Subject: Final Environmental Assessment
Shoreline Setback Variance Permit Application
SSV-95-1
TMK: 2-8-20: 4 Poipu, Kauai
Fredrick G. Synder, Applicant

POIPU MAKAI RESORT

COMMENTS BY UNIVERSITY OF HAWAII
RESPONSE TO COMMENTS

Draft Environmental Assessment (EA)
Poipu Makai Resort - Slope Stabilization
Poipu, Kauai

Rev 6-21-94 $\frac{1}{2}$

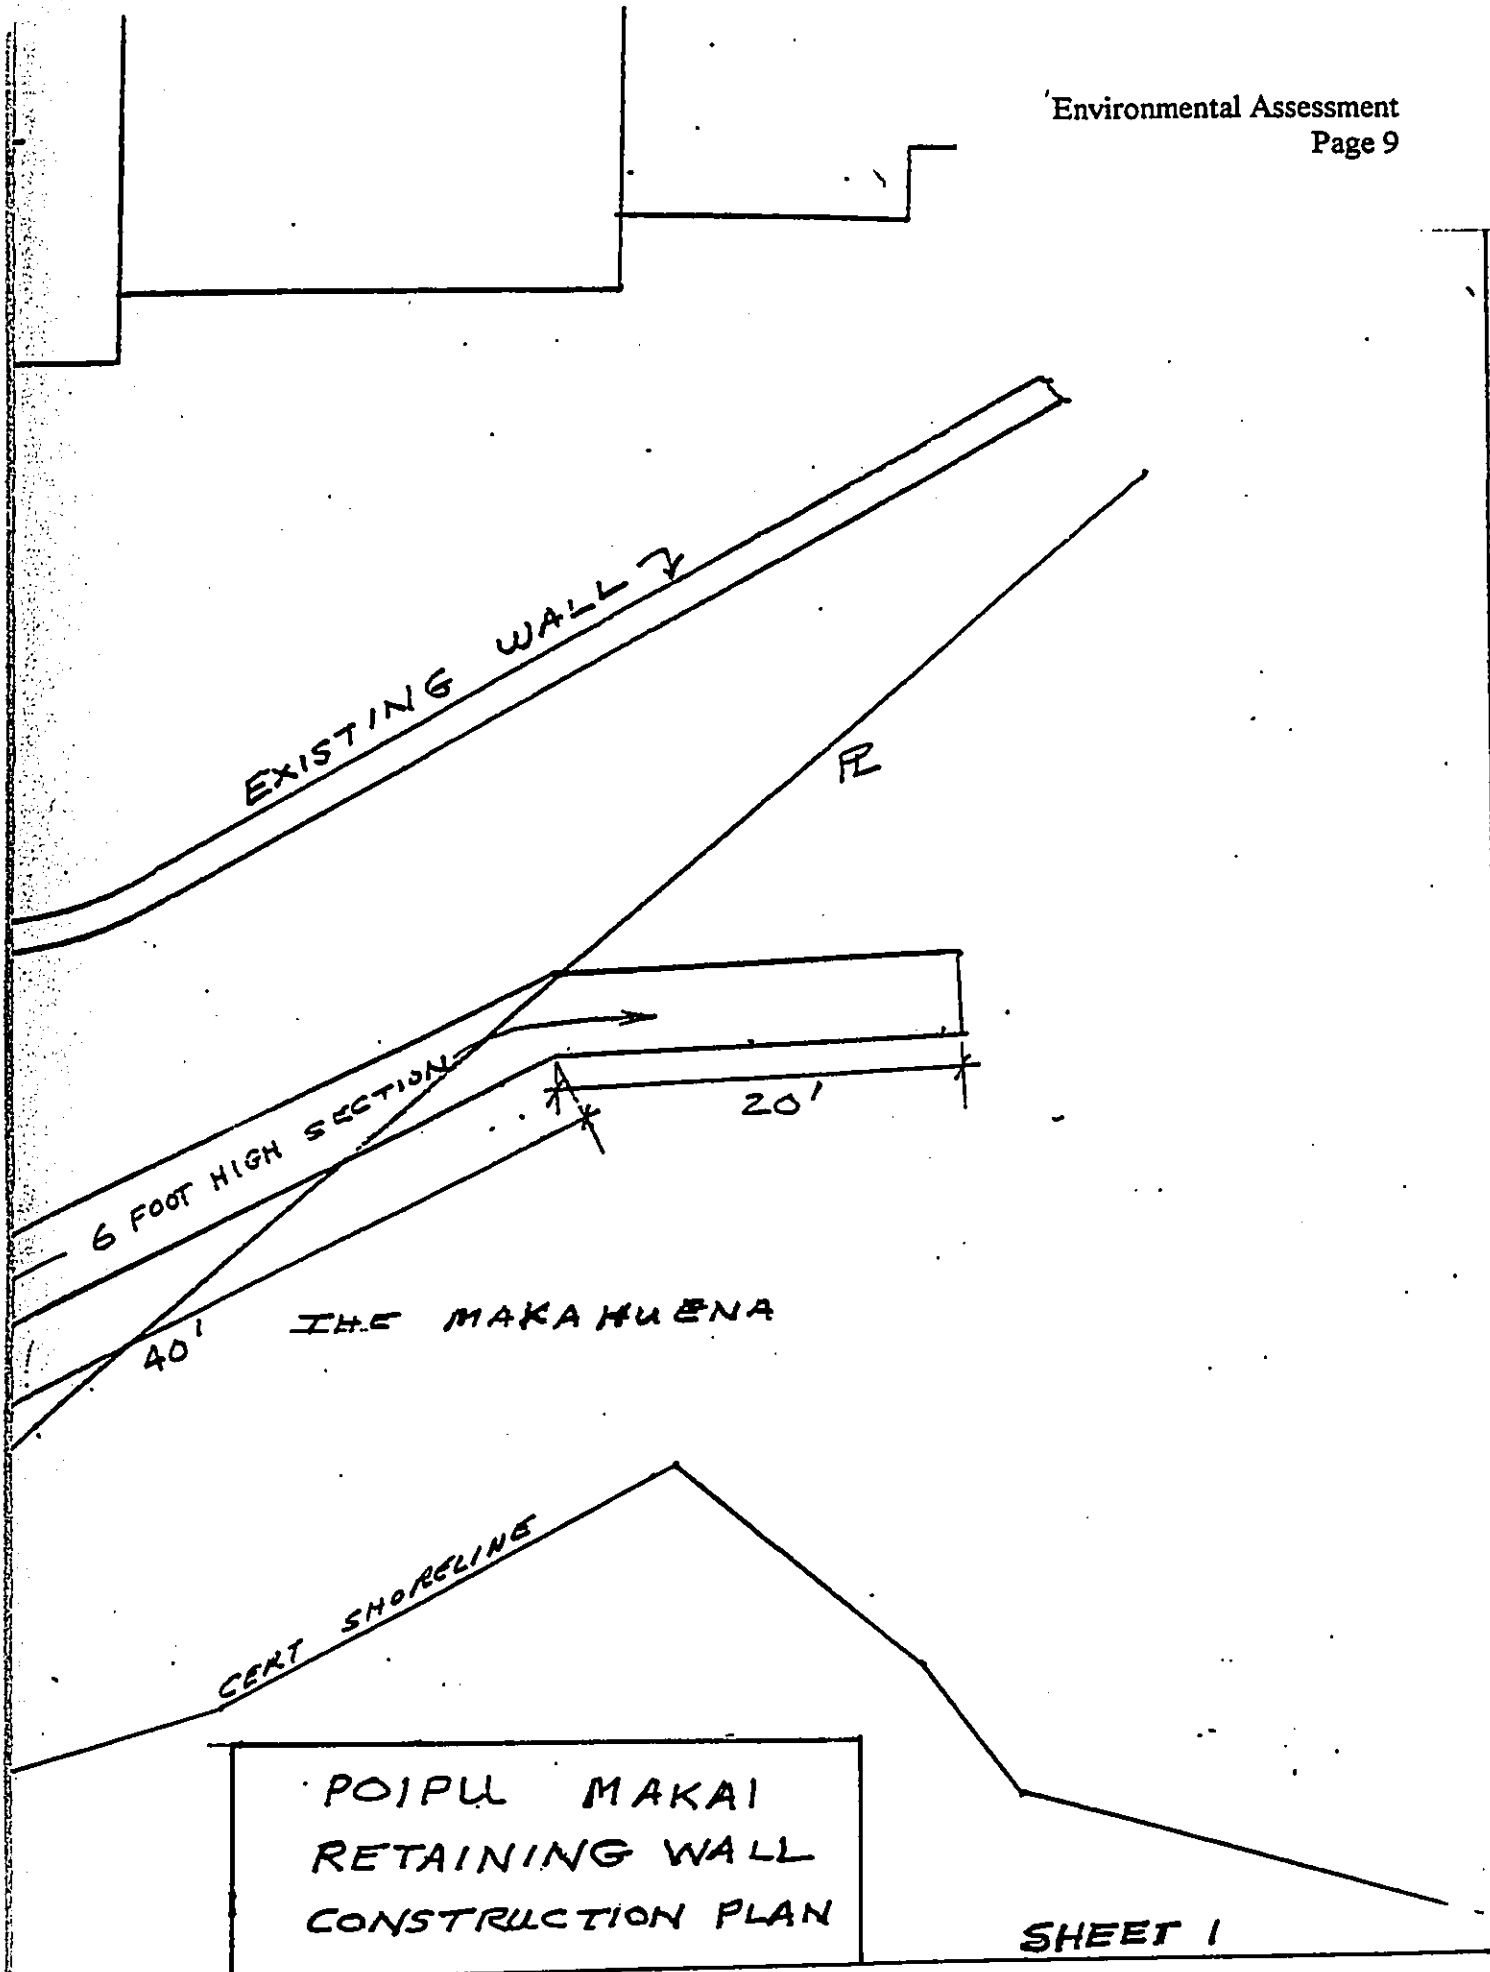
Also, the Draft EA claims that the proposed wall follows the contour of the coast, but the diagram on Sheet 1 shows it to be distinctly angular. Since the coastline and the ocean are not shown on Sheet 1, however, the relationship between the wall and the coastline is unclear and needs to be clarified.

5. The rocky ledge that the wall will be founded on is a very hard Pahoehoe lava flow. It will provide a very sound foundation for the wall.
6. The revised site plan dated 6-21-94, shows the relationship between the seawall and the certified shoreline for this property and adjacent properties.
